FINAL  
ENVIRONMENTAL IMPACT REPORT

MARIPOSA INDUSTRIAL PARK

State Clearinghouse Number: 2020120283

February 28, 2022

Figure 3-1  
STOCKTON AB 617 COMMUNITY

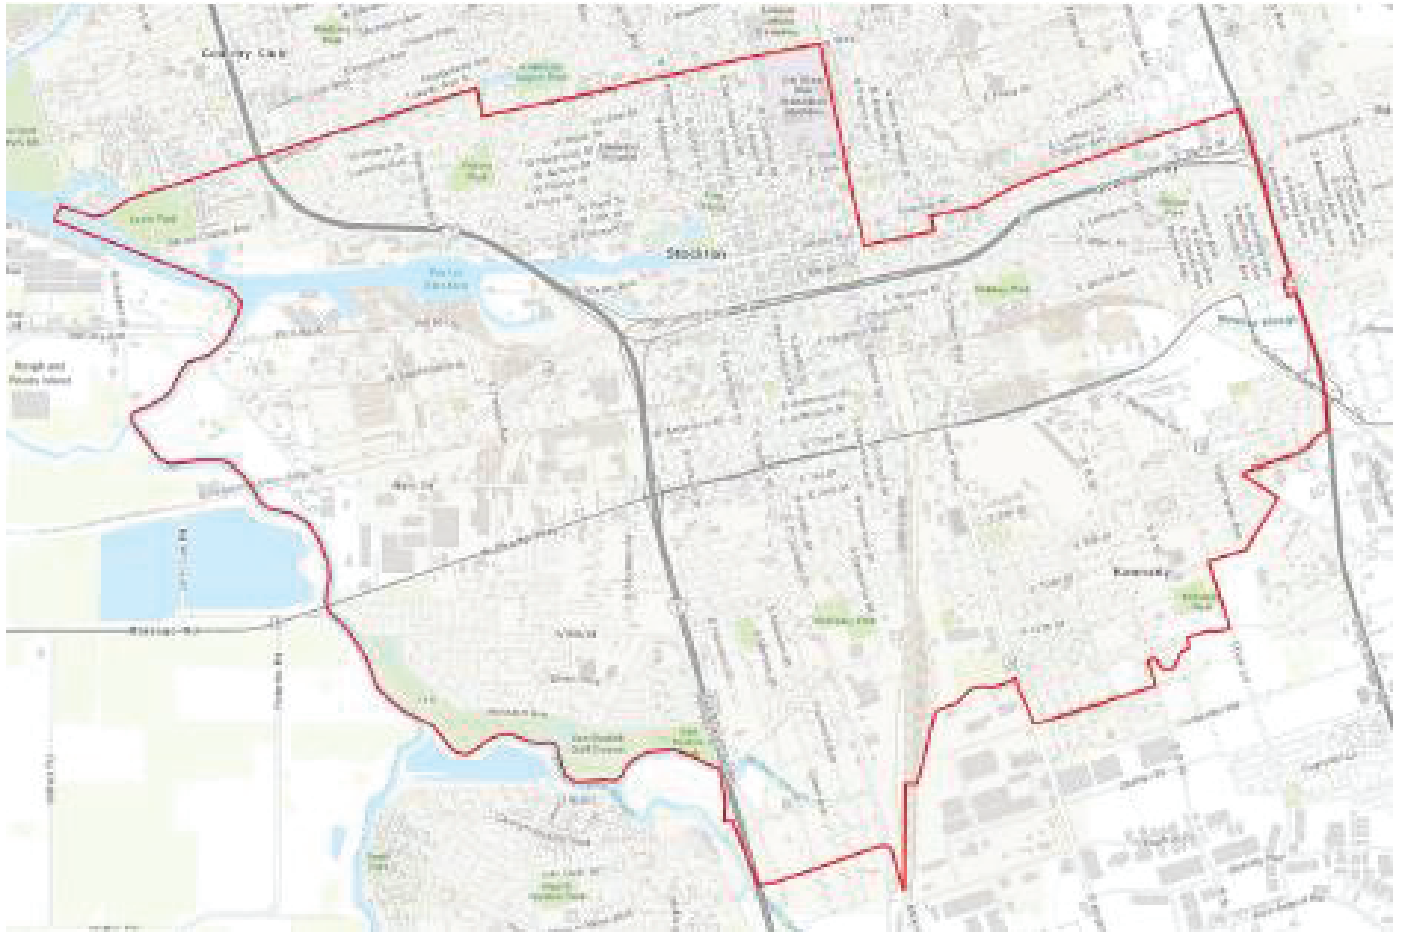
Response 3D: Statewide concerns regarding disproportionate local impacts of air pollution in disadvantaged communities led to the adoption of AB 617 in 2017. The intent of AB 617 is to rectify disproportionate pollution exposure by establishing monitoring networks; developing, implementing and tracking emission reduction programs; and funding

these programs with the assistance of local steering committees in identified Community Emissions Reduction Program (CERP) communities. Stockton was selected to receive AB 617 planning and funding resources resulting in preparation and adoption of the Stockton CERP in 2021, which is applicable to the CERP area shown on Figure 3-1 of this FEIR.
